<b>Title - Sujet</b> Sinclair Canyon Electrical Upgrade	
<b>Solicitation No. - N° de l'invitation</b> EP922-172961/A	<b>Amendment No. - N° modif.</b> 011
<b>Client Reference No. - N° de référence du client</b> Parks EP922-172961	<b>Date</b> 2017-03-13
<b>GETS Reference No. - N° de référence de SEAG</b> PW-\$PWU-183-11007	
<b>File No. - N° de dossier</b> PWU-6-39328 (183)	<b>CCC No./N° CCC - FMS No./N° VME</b>
<b>Solicitation Closes - L'invitation prend fin</b> <b>at - à 02:00 PM</b> <b>on - le 2017-03-16</b>	
<b>Time Zone</b> Fuseau horaire Mountain Daylight Saving Time MDT	
<b>F.O.B. - F.A.B.</b> <b>Plant-Usine:</b> <input type="checkbox"/> <b>Destination:</b> <input type="checkbox"/> <b>Other-Autre:</b> <input type="checkbox"/>	
<b>Address Enquiries to: - Adresser toutes questions à:</b> Tikhonovitch (RPC), Alex	<b>Buyer Id - Id de l'acheteur</b> pwu183
<b>Telephone No. - N° de téléphone</b> (780) 901-7940 ( )	<b>FAX No. - N° de FAX</b> (780) 497-3510

Sinclair Canyon Electrical Upgrade and Site Rehabilitation, BC  
The following outlines responses to requests for information:

CONCRETE CURB & GUTTER  
REPLACEMENT DETAIL

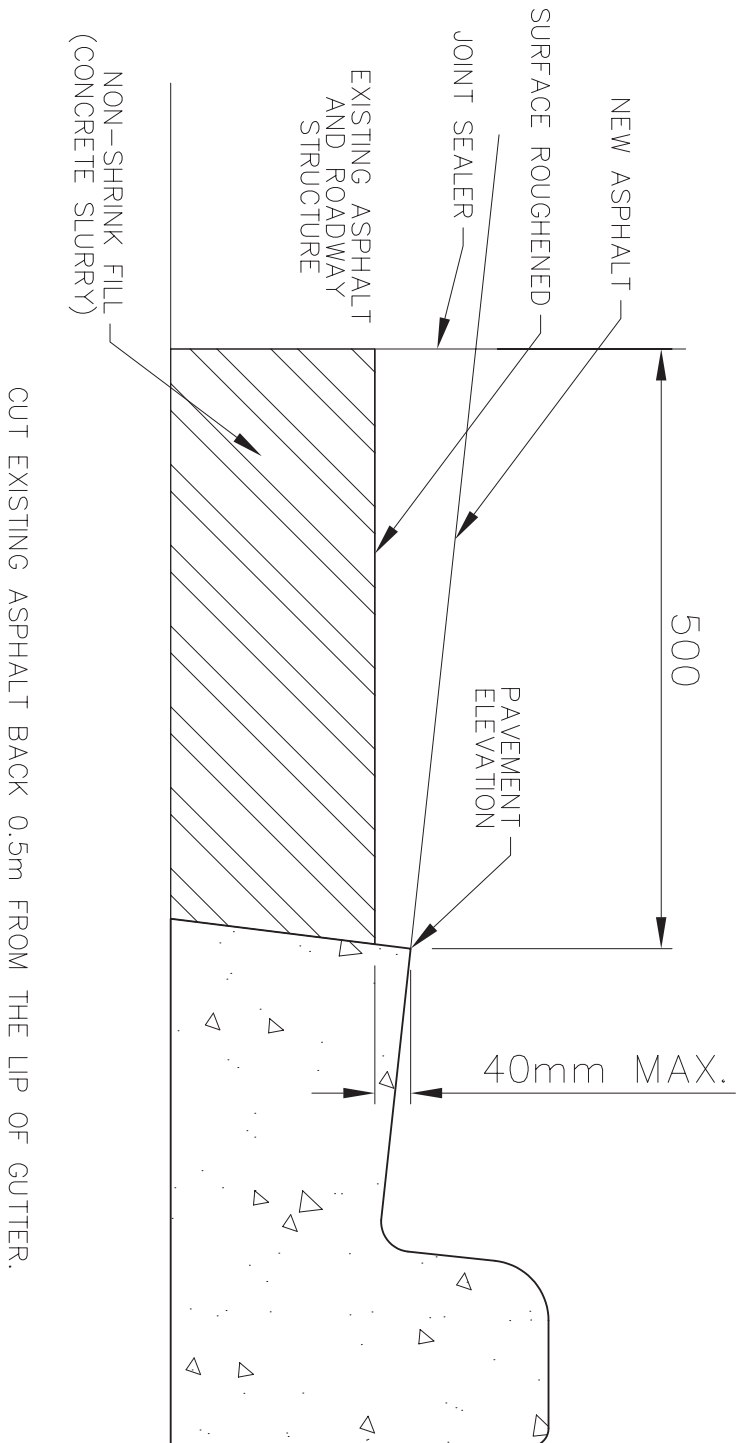
27	In the Project Documents there is a requirement for crack sealing, is there any requirement for this work relative to the joint created between replacement & existing asphalt pavement and where the C&G meets the asphalt pavement?	Joint sealer shall be used to seal the joint created between the replacement & existing asphalt pavement.	2017-Mar-13
28	Addendum #4 mentions the requirement to remediate deep utilities, where is this work identified?	The deep utilities scope of work is as identified on the civil drawing package labelled as "C" series. Work included pertains to Catch basin remediation and associated works. Refer to drawings and spec.	2017-Mar-13
29	Question # 20 is confusing, please explain "Widen the section of road"?	Contractor is to remove 0.5m of the existing road from lip of gutter. The initial measurement of the removal was 0.3m from lip of gutter. Please see the attached detail outlining the curb and gutter replacement for further clarification.	2017-Mar-13
